DumGal Against Pylons (DGAP) Alternative to SPENs Proposal

1 Introduction

Figure 5

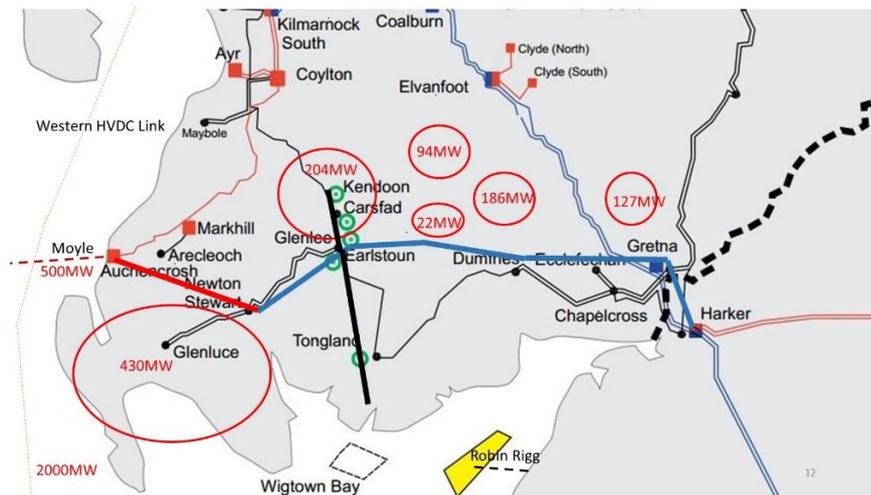
SPENs proposal as set out in Figure 5, therefore, is suggestive of a scenario (not unreasonable in the circumstances) founded a) on a lack of detailed information about the extent of future renewable generation connection requirements and b) the application of design rules in which, in the presence of doubt, the best solution appears to be to double the number thought of and then add yet more to cope with future expansion.

Against this background, and assuming the renewable generation set out in Figure 4 turns out to be a reliable estimate then SPENs proposal in Figure 5, leaving aside any unknown additional renewable generation that may need to be connected in future, suggests the 400kV network would operate for the majority of time at somewhere in the order of 30% capacity. This would be a significant under-utilisation of resource and as an investment would not represent best value for money even taking account of the need for 'future-proofing.'

Figure 5

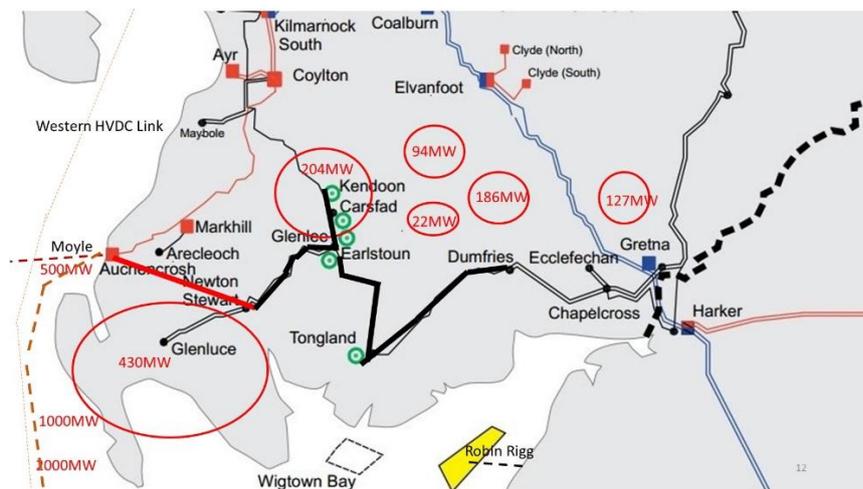
DGAPs proposal is predicated on the use of a sub-sea link of sufficient rating to accommodate the additional renewable energy that is anticipated to occur in the west of the region. At 1000MW rating such a link, landing at Auchencrosh, would be around 50% loaded depending on the direction and magnitude of load flow through the Moyle Interconnector and the power available from renewable sources. Elsewhere, as shown in

Figure 6, SPENs proposed 400kV transmission network could be down-rated to 132kV (shown black). It is likely, but by no means a foregone conclusion, that with the sub-sea link in place, the Newton Stewart to Auchencrosh proposal based on a 275kV transmission voltage will have to remain in order to accommodate the additional renewable generation converging on Newton Stewart from Kendoon to Glenlee and that connected to a new substation at Newton Stewart from the Glenluce area. Some parts of this line, particularly where there is a high visual impact, could be mitigated by undergrounding.

The alternative 132kV network will require to be uprated to some extent and this will entail the replacement of the existing 22.6m tall pylons with, in all likelihood, L7(c) pylons which stand 26.2m tall. The overhead conductors will also need to be uprated to a maximum of 520MW depending on the results of a load flow analysis. At this level of capacity the Great Britain Security and Quality of Supply Standard (GBSQSS) is satisfied for any double circuit fault as the winter peak in 2024/25 between Tongland and Dumfries is calculated, in the worse-case scenario, to be constrained at 459MW.²⁵
